Doc 70-36
5-8

United Nuclear Chem. Feb. 24, 1964

Shipping Cont B.E 1351

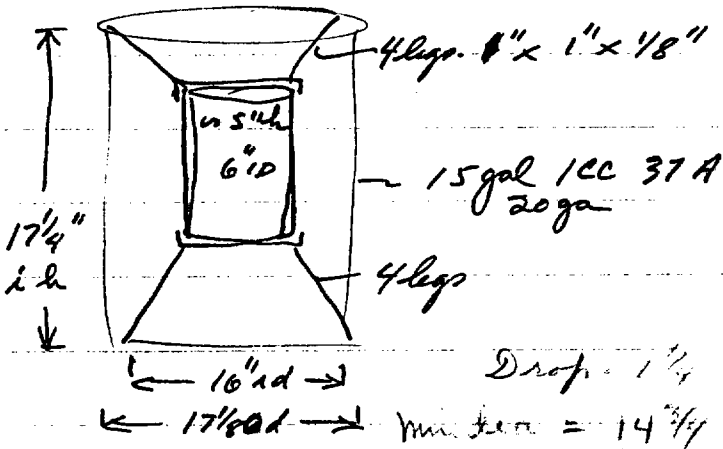
Vol pot 2316 cc
 Max bulk Vol SNM 1280 cc
 Max wt (R=6) = 7680
 Vol solid (R=10) = 768 cc
 Void vol $\frac{1280 - 768}{512 \text{ cc } 40\% \text{ void}}$

$C_{bulk} = 6$ for cpts.
 $C_{solid} = 10$ for cpts.
 Space filled w. foam glass or plaster of paris

Em	H/x	Ms	Kg x/cont
93	2.1	9 Ks	6.3
50	4	7.3 Kg	3.4
10	20	3.6 Kg	.63
5	40	3.6 L	.32

Stowed "Double Stack"

OK
 on receipt
 on 30/1/64

Concurred by GDZ (no RO permission) for exel use a cert with no interim unloading or transshipment.
